# NFPA 90A

## Standard for the Installation of Air-Conditioning and Ventilating Systems

**F.I. No.:** 90A-02-04

Formal Interpretation

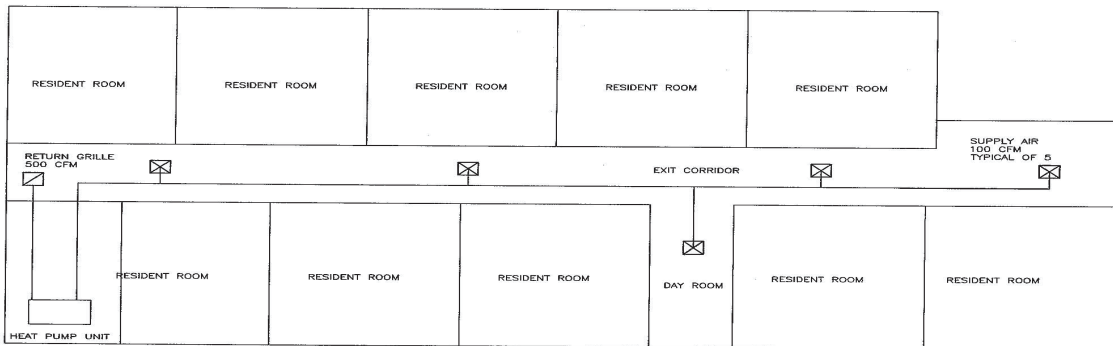
**Question No. 1:** Is the intent of the paragraph to require multiple locations for return air in a corridor?

**Question No. 2:** Is one point of return air with multiple supply air locations as indicated on the attached sketch acceptable?

**Answer:** No.

**Answer:** Yes.
